**COMBINED PRELIMINARY AND FINAL DRAINAGE
REPORT**

**OHANA SUBDIVISION
EL PASO COUNTY, COLORADO**

October 28, 2021

Figure 1: Zoomed view of FIRM including proposed subdivision.

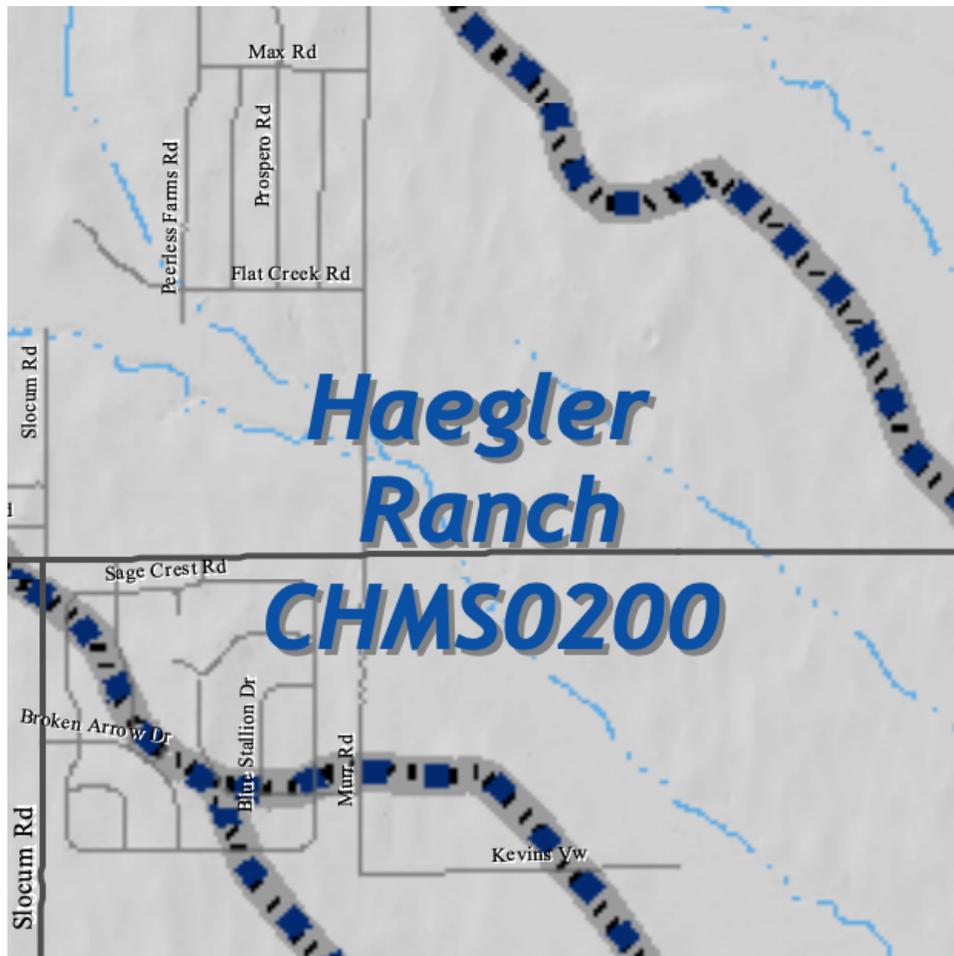
State that this area will be a "No-build area" on the plat.
